Item 7.**Development Application - 82 City Road, Chippendale****File No.:** D/2018/842**Summary****Date of Submission:** 24 July 2018**Applicant:** Merbell Pty Ltd**Designer:** Cubitor Design And Drafting**Owner:** Merbell Pty Ltd**Cost of Works:** \$533,421**Zoning:** R1 - General Residential. Boarding houses are permissible with consent in the zone**Proposal Summary:** The application seeks consent for alterations and additions to the existing 10 room boarding house at No.82 City Road, Chippendale. The works consist of tree removal, excavation, partial demolition of the rear of the building, internal alterations, rear ground and first floor extensions, rear facing dormer window and a new rear lane structure. The proposal will result in 1 additional room resulting in the boarding house being an 11 room facility. The application is being assessed concurrently with an identical proposal for the neighbouring property at 84 City Road (D/2018/841), which is under the same ownership as the subject site.

Summary Recommendation: This proposal is recommended for refusal.

Figure 13: Section

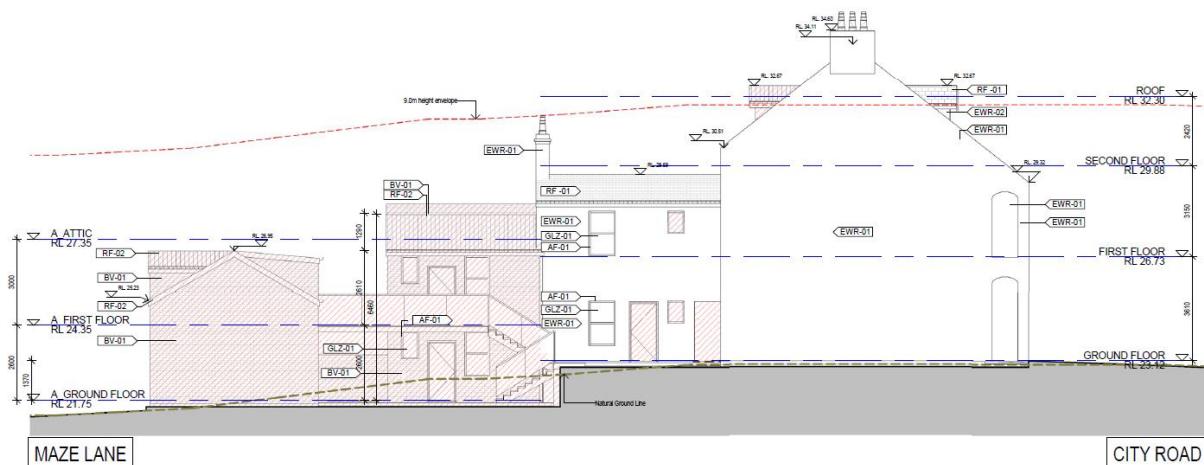
34. The site is subject to a maximum height control of 9m. The proposed development involves the addition of a new rear facing dormer window at a height of 9.55m. It is noted that the existing building has a maximum height of 11m to the ridge line.
35. A written request has been submitted to Council in accordance with Clause 4.6(3)(a) and (b) of the Sydney LEP 2012 seeking to justify the contravention of the development standard by demonstrating:

38. The written request states that the development is consistent with the objectives of the height development standard as the area of non-compliance is located below the existing ridgeline and is appropriate to the condition of the site and its context.
39. In accordance with the justifications set out in *Wehbe v Pittwater Council (2007) 156 LGERA 446*, the written request has demonstrated that the objectives of the height development standard are achieved notwithstanding the non-compliance with the standard. Accordingly, it is considered that the applicant has adequately demonstrated that strict compliance with the height development standard is considered unreasonable and unnecessary in the circumstances of the subject application.

40. The written request has demonstrated that the non-compliance associated with the dormer window will result in an outcome that generates no visual impact to the streetscape, is under the height of the existing ridgelines, and will not result in adverse privacy or overshadowing impacts. Accordingly, it has been demonstrated that there are sufficient environmental planning grounds to justify contravening the standard.

Figure 15: Proposed Maze Lane elevation

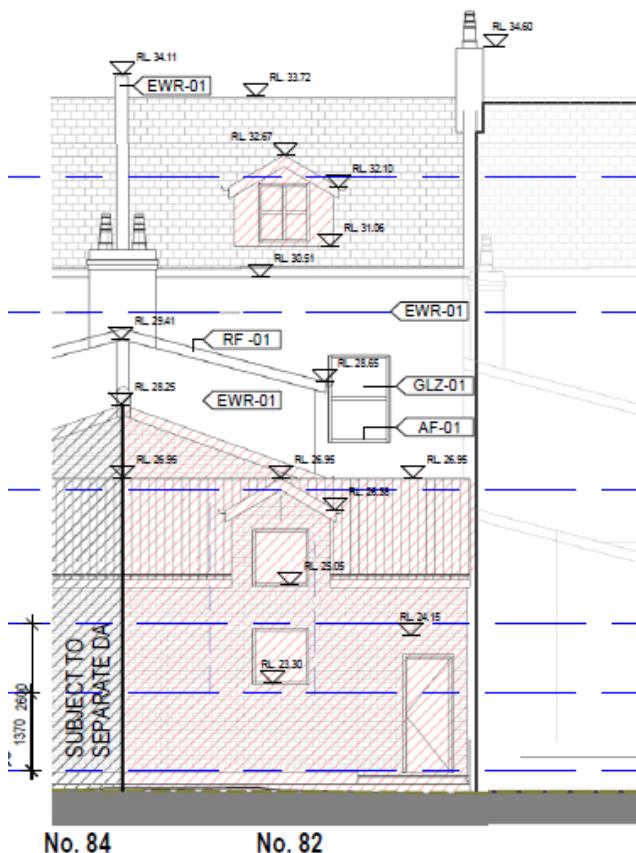
87. The rear laneway development proposed has a total height of 5.2m as measured from the lane in keeping with the maximum permissible height of 5.4m. The roof pitch is at 40 degrees however the laneway dormer windows are not set in from the boundary by 300mm as required. This is required in order to ensure the building presents as a single storey form as viewed from the lane. This is a minor non-compliance and could be addressed by way of amended plans, however, the application is recommended for refusal for reasons outlined elsewhere in this report.
